Service Bulletin

No. : MZ07-082

Model: SA-7S1, SA11S1, SA-15S1, SA8001

Subject: Software Update Information (on improving the playability of the RoHs-compliant pickup)

RoHs compliant pickup

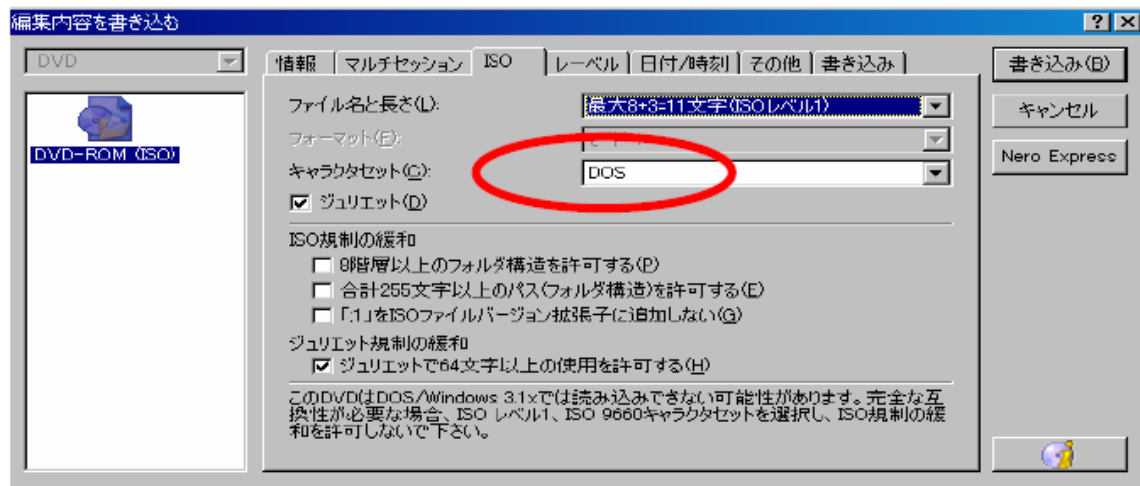
Solution: When servicing units with RoHs-compliant pickups (see below) or replace noncompliant pickups with compliant ones, please update the software.

Replacing R502

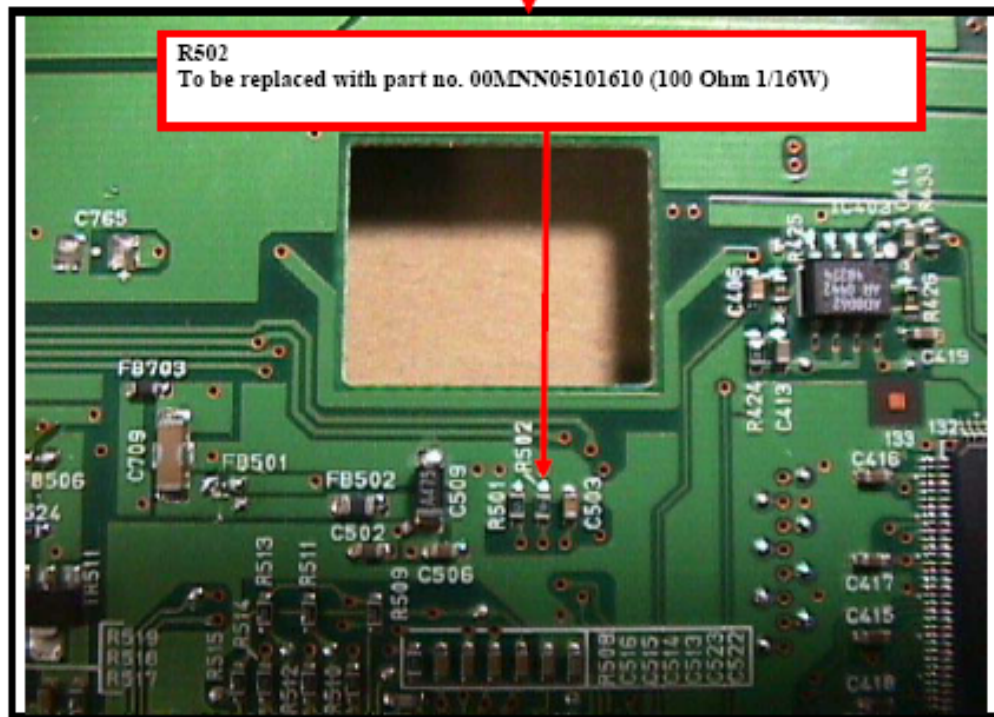
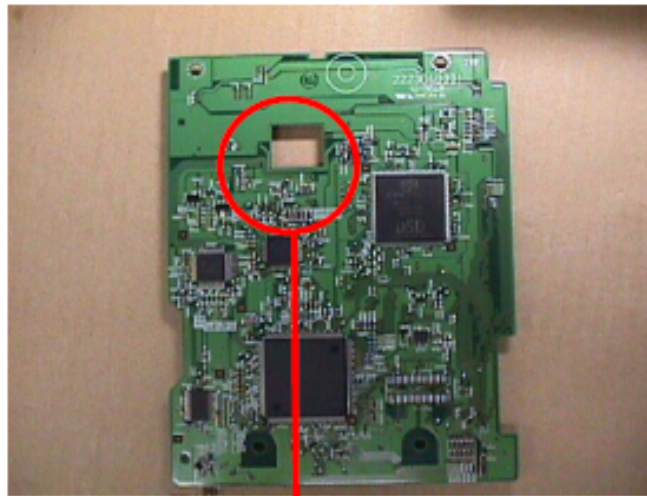
Some units may need a resistor replaced as well as updating. When updating the software of units with the following serial numbers, please replace their R502 with a 100 Ohm.
